DEVELOPMENT REVIEW BOARD  
SUPPLEMENTAL SUBMITTAL

PROJECT NO. 2018-001579

SUBMITTAL DESCRIPTION: Departmental comments indicated a number of items to be addressed in a deferred hearing date, indicated above for multi-family apartments project at 7500 Indian School Rd in the Winrock Town Center. Responses to the comments and revised sheets are provided.

This letter outlines the modifications that have been made to the Apartments at Pennsylvania St and Indian School Rd application for a major site plan amendment to the approved Winrock Town Center Site Development Plan (PR-2018-001579) to address the agency comments that were received.

City Project No. **XXXX.XX** Zone Map No. **J-19** Sheet **C400** Of **4**

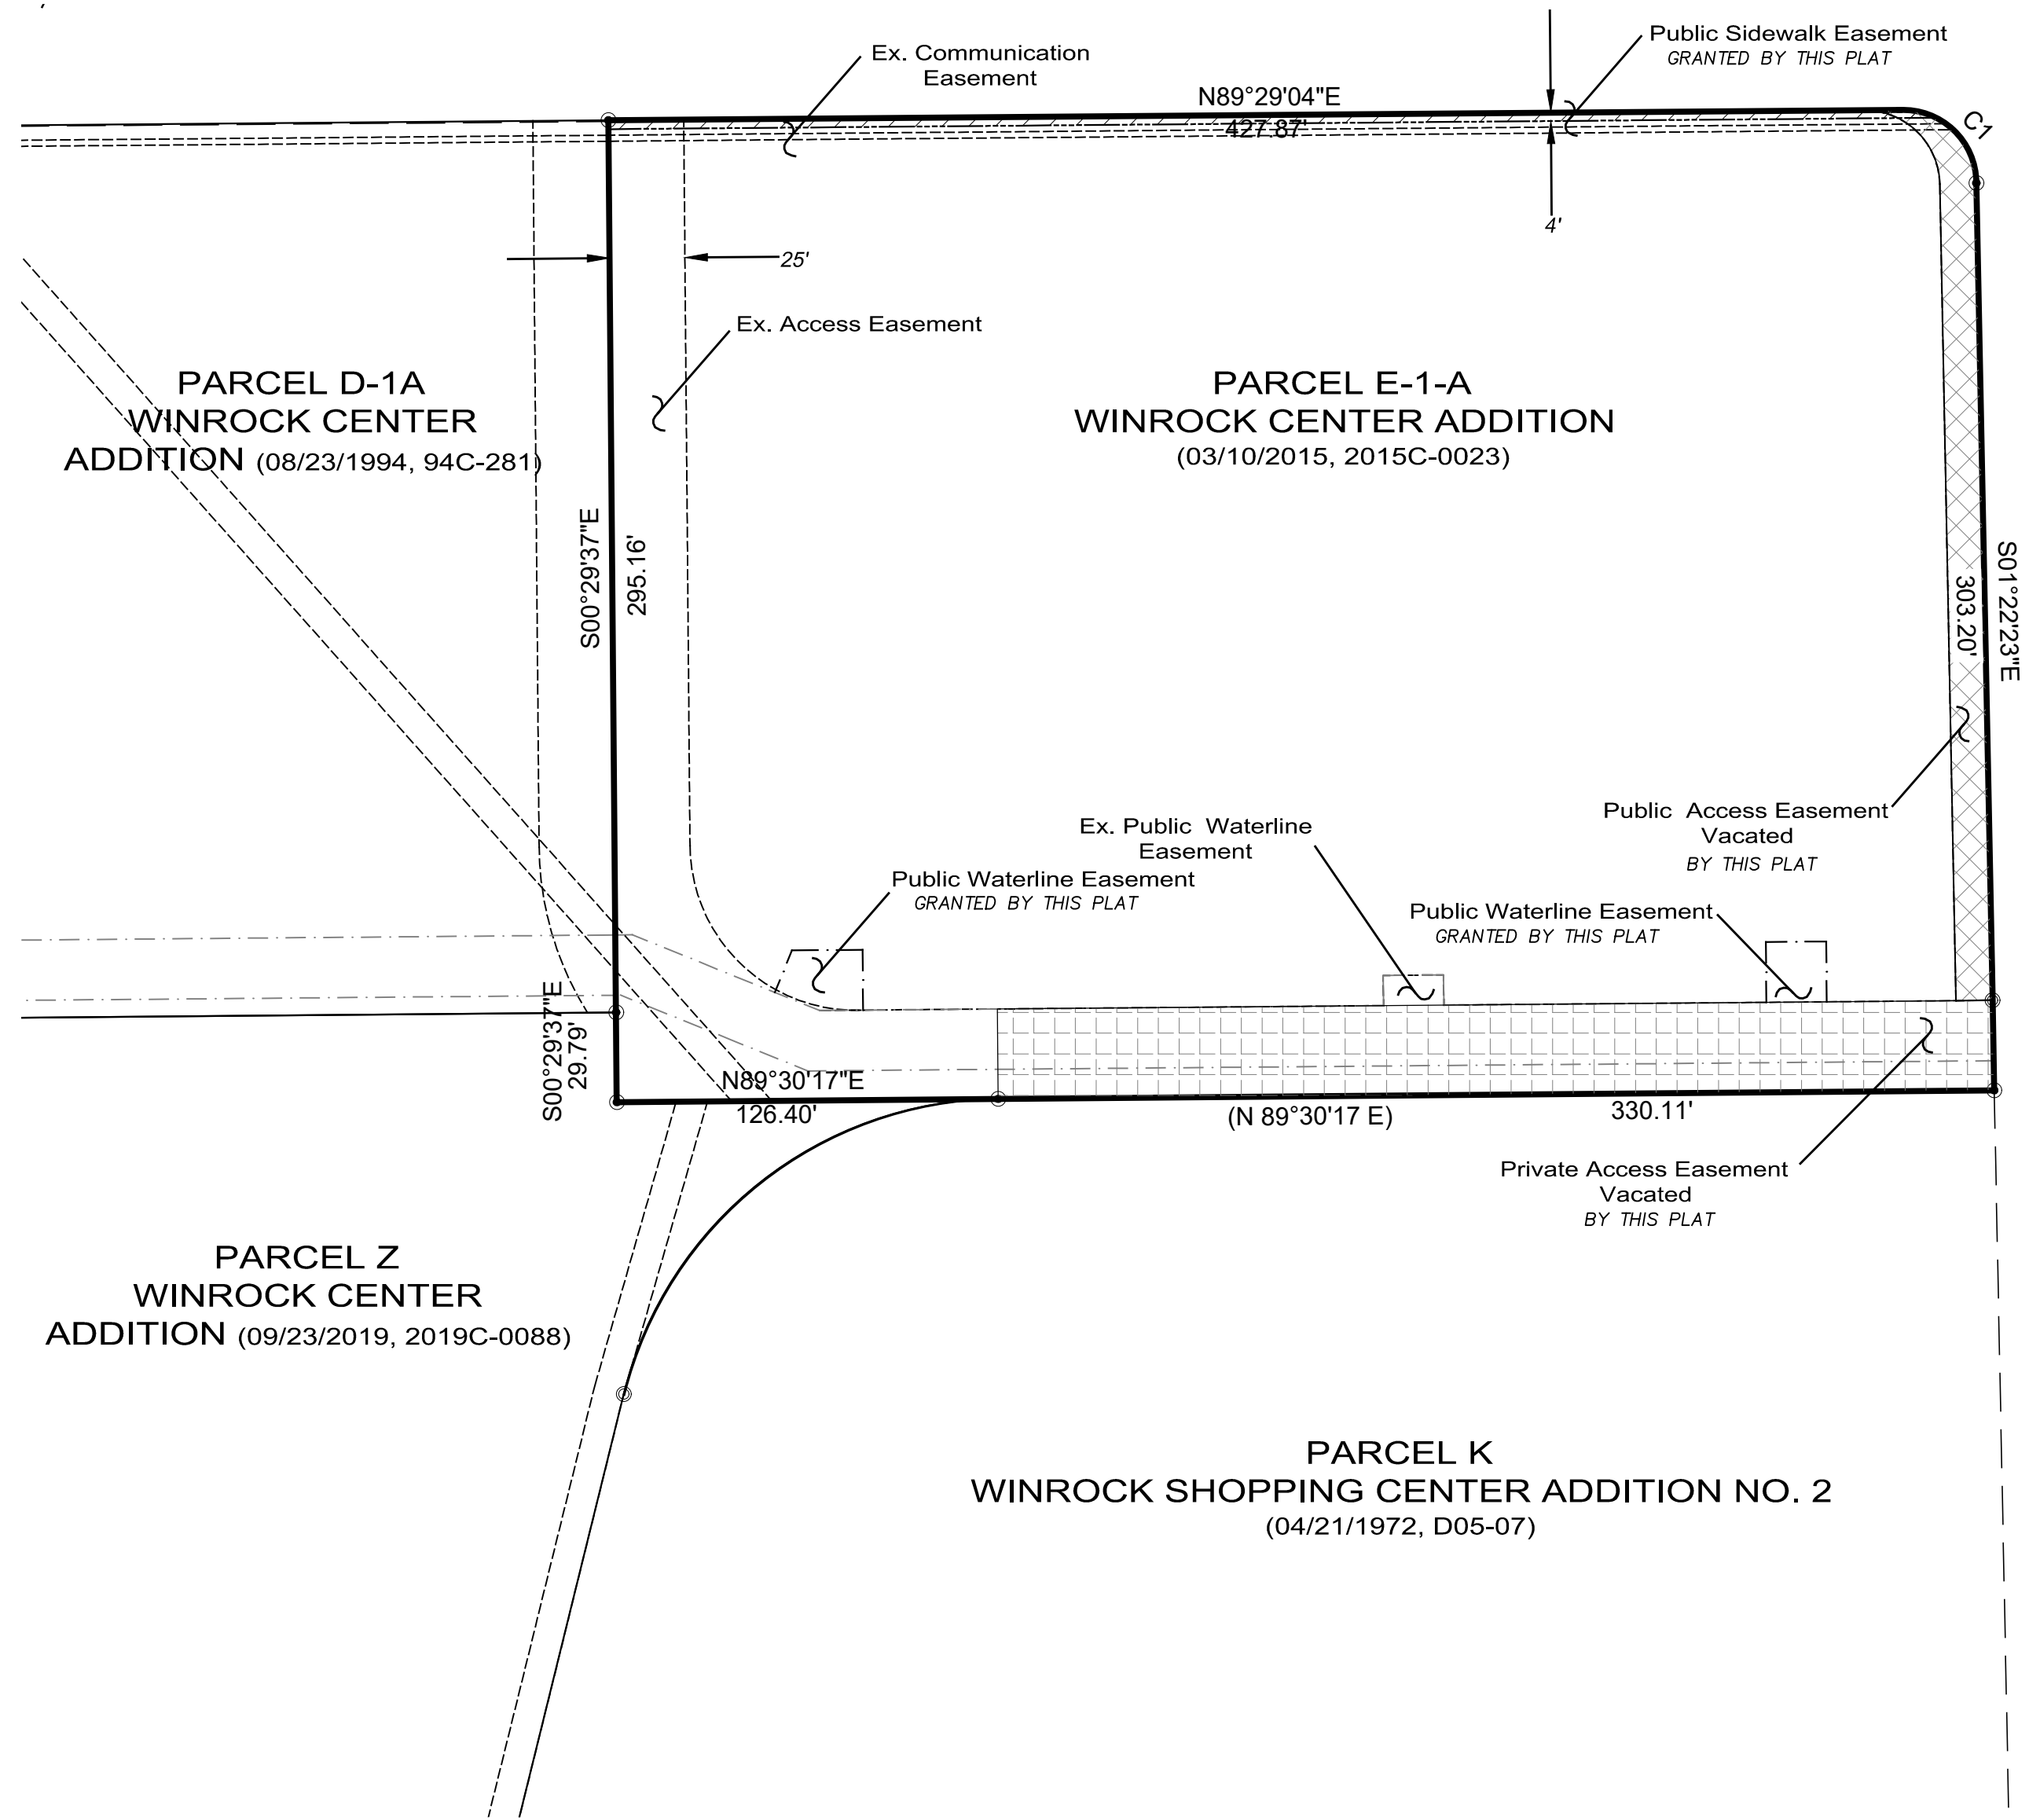
3. For road exiting onto Indian School Road, show a cross-section. Used a keyed note for striping and include a note for the centerlane lane as well. Show proper transitioning. Call out pavement arrows, and provide dimensioning for the lanes.

7. Call out width of raised crosswalk on the detail provided.

7. PREVIOUS COMMENT: What is the horizontal clearance between the proposed private sanitary sewer along the south property line and the existing public waterline? Is the appropriate clearance provided? Is the proposed sanitary sewer encroaching into the public waterline easement?

- b. The response to comments indicated the existing public waterline easement is shown but that is not the case. Please show and indicate if the private sanitary sewer encroaches the existing public waterline easement which is not allowed.

*Keyed notes for asphalt striping and directional arrows have been added. Road cross-section was added to sheet C400.*

*Raised crosswalk width has been labeled and road cross section added to sheet C400.*

*Cross-section added Sheet C400.*

*The easement is labeled and cross-section added to Sheet C400.*

FINAL PLAT  
 PARCEL E-1-A  
**WINROCK CENTER ADDITION**

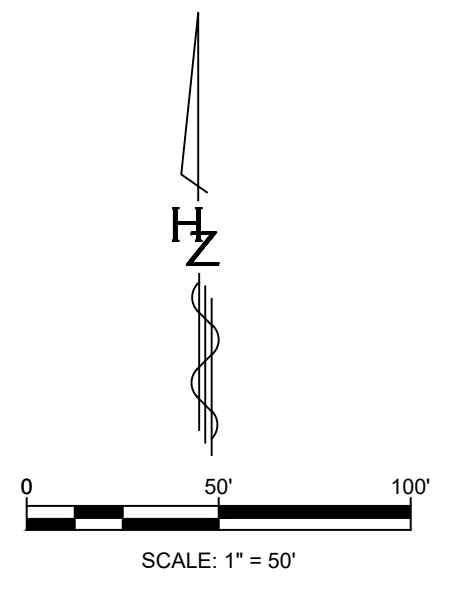
1. The Transportation Department has no objection to the sidewalk width waivers, easement vacation. For the plat, dedicate right-of-way to include the full width of sidewalk on Indian School Road.

- c. There is a proposed plat included with the submittal which shows public waterline easements being granted. When the plat comes through DRB, it should only grant easements associated with public infrastructure (i.e. water meters). It should not grant easements for private fire hydrants.  
*Plat updated.*
- d. VA-2020-00469 – WAIVER TO IDO: No objection.

*See final plat.*
